ECE/TRANS/WP.29/GRRF/2002/17/Rev.5  
21 November 2005

World Forum for Harmonization of Vehicle Regulations (WP.29)

REVISED PROPOSAL FOR DRAFT AMENDMENT TO REGULATION No. 64 \*/  
(Temporary use spare wheels/tyres)

Transmitted by the expert from the United Kingdom

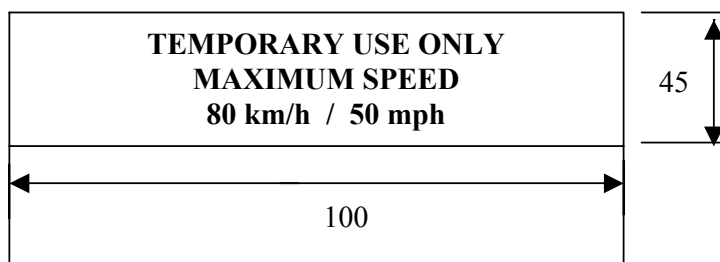
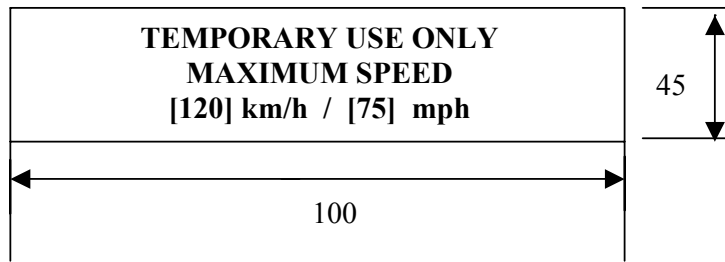
Paragraph 5.1.4.1., amend to read (the diagram is not amended):

"5.1.4.1. An 80 km/h maximum speed warning symbol arranged in accordance with the diagram below shall be permanently displayed on the outer face of the wheel in a prominent position.

In the case of vehicles intended to be sold in countries using imperial units of measurement, an additional warning symbol, identical to that described above, with the exception that the figure "80" shall be replaced by "50" and the wording "km/h" by "mph", shall be permanently displayed on the outer face of the wheel in a prominent position.

Alternatively a single warning symbol arranged in accordance with the diagram below, shall be permanently displayed on the outer face of the wheel in a prominent position.

Upper case letters shall be at least 5 mm high and the numbers "80" and "50" shall be at least 20 mm high with the elements that make up each character of the number at least 3 mm line thickness. Lower case text shall at least have a line height of 5 mm. All text shall be enclosed in a border and be on a background of contrasting colour.

The requirements of this paragraph shall only apply to types 1, 2 and 3 temporary use spare unit as defined in paragraphs 2.11.1., 2.11.2. and 2.11.3."
